RE: Notice of Work Complete
331 Killingworth Road
Guilford, CT
Sprint Site #: NV2.5_CT03XC068
EM-SPRINT-060-140605

Final Report of Special Inspections

Project: CT03XC068-A NORTH GUILFORD/ SPRINT PCS (NV2.5 PROJECT)

Subject: Modification Inspection Report

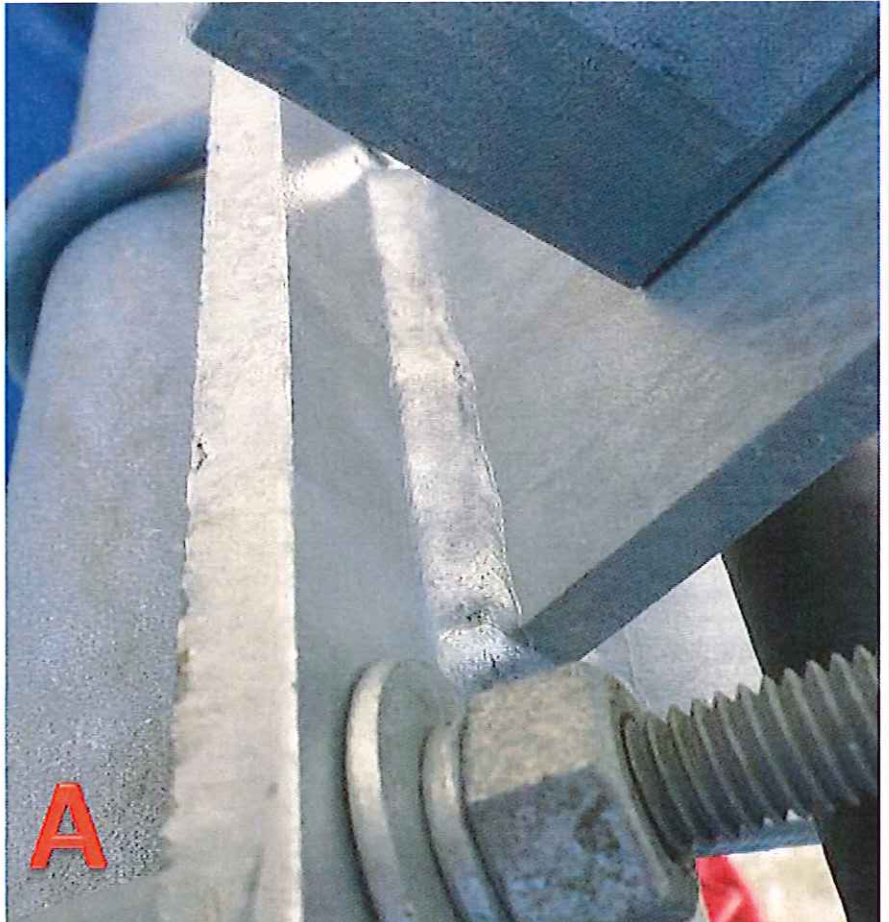
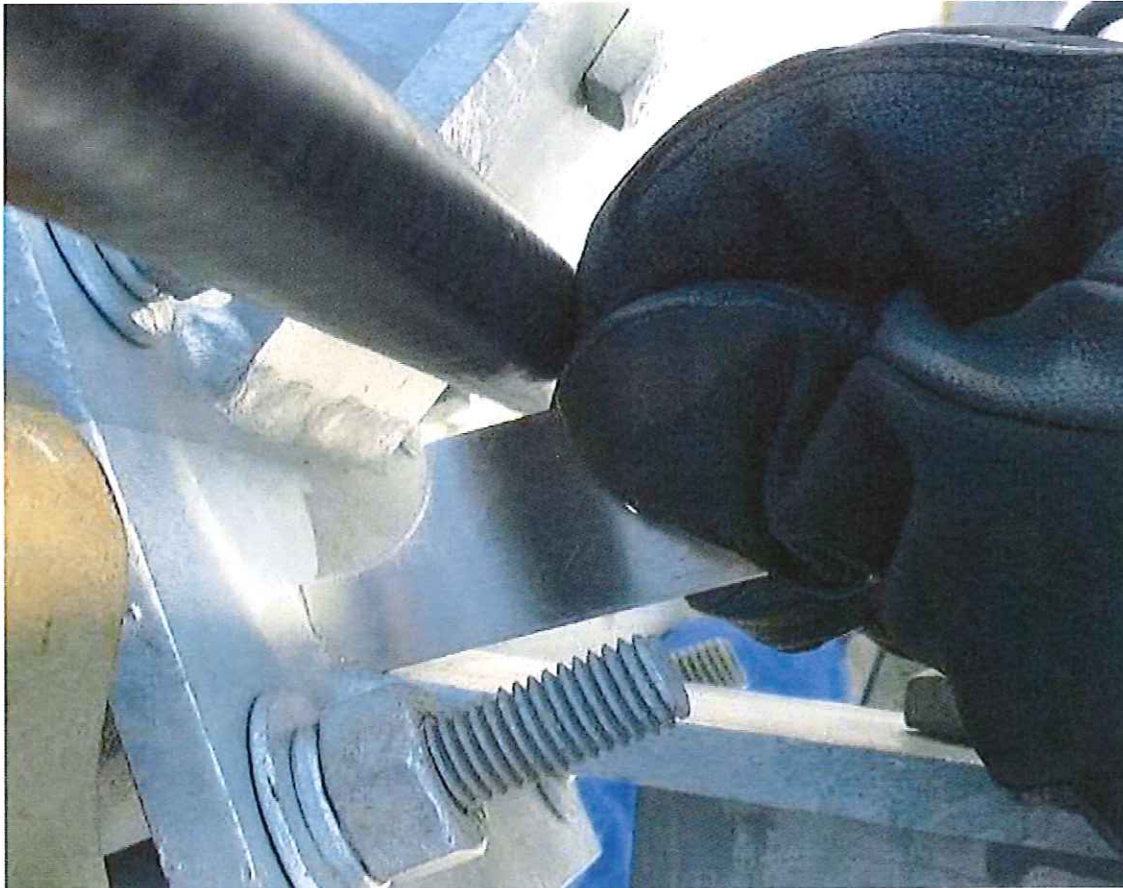
1) New V-Bracket Assembly Plates at elevation 110'.
 A. Typical weld profile on tower legs a, b, and c is shown in photos "A".
 B. Typical weld size on tower legs a, b, and c is shown in photo "B".

RESULTS:
 1) ALL WELDS WERE FOUND TO BE ACCEPTABLE TO CODE AT TIME OF EXAMINATION

SHEET TITLE: SUBHORIZONTAL REINFORCEMENT DETAILS II
 SHEET NUMBER: S-3

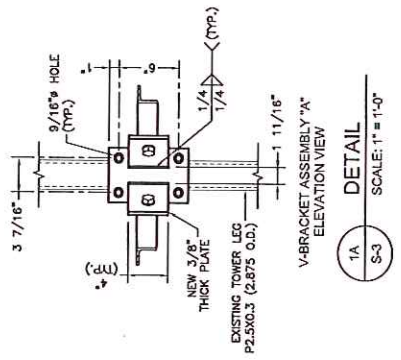
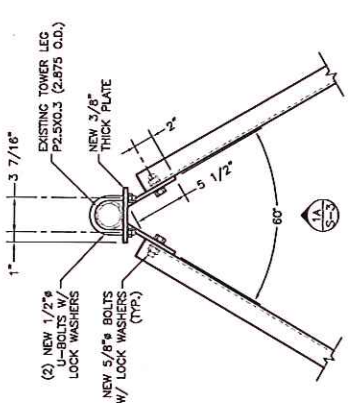
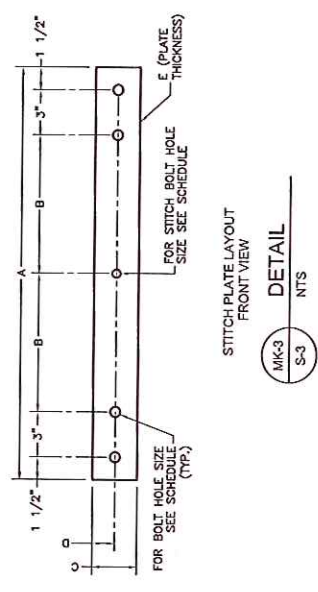
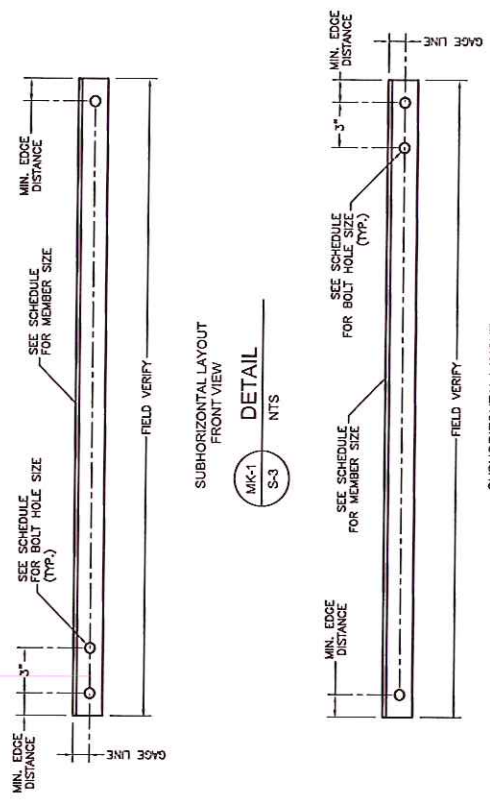
1. Replace flat washers with lock washers to prevent nuts from coming loose.

SECONDARY INSPECTION
 EOR has reviewed the issues noted and passed the as-built condition(s).
 GC has revisited the site and corrected the punchlist items shown. Documentation showing these corrections has been received by the EOR.
